Office Action Summary	Application No. 10/817,531	Applicant(s) SCHAEPKENS ET AL.	
	Examiner Allan R. Wilson	Art Unit 2815

DETAILED ACTION

The following copy of Kumar's Fig. 2 will be used for rejection of claims 3-5:

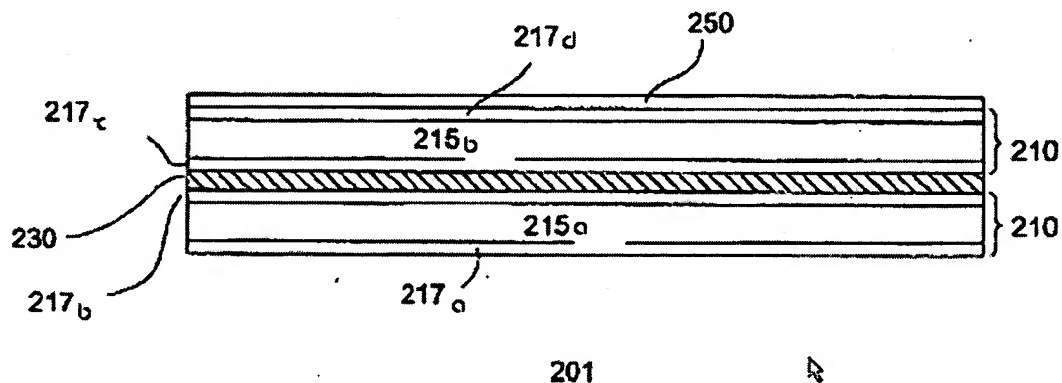
With regards to claim 2, Kumar illustrates in Fig. 2 the flexible substrate 201 comprises the barrier coating 217.

With regards to claim 3, the above fig. illustrates a first protective layer 217_a configured to resist abrasion ; a polymeric transparent film 215 coupled to the first protective layer; a barrier coating 217_c coupled to the transparent film; and a second protective layer 217_d coupled to the barrier coating and configured to protect the transparent film from chemical attack during fabrication.

The limitations “resist abrasion” and “protect the transparent film from chemical attack during fabrication” is an inherent function of the material. Kumar discloses in col. 2, lines 38-

41, the barriers are metal oxide, silicon oxide or nitrides; which are abrasion and chemical resistant.

With regards to claim 4, the above fig. illustrates a first protective layer 217_a configured to resist abrasion; a first polymeric transparent film 215a coupled to the first protective layer; a first barrier coating 217_b coupled to the first transparent film; a second barrier coating 217_c coupled to the first barrier coating via an adhesive layer 230; a second polymeric transparent film 215b coupled to the second barrier coating; and a second protective layer 217_d coupled to the barrier coating and configured to protect the transparent film from chemical attack during fabrication.

With regards to claim 5, the above fig. and Fig. 5 illustrates a barrier coating 217_d coupled between the flexible substrate 201a and the organic electronic device 560.
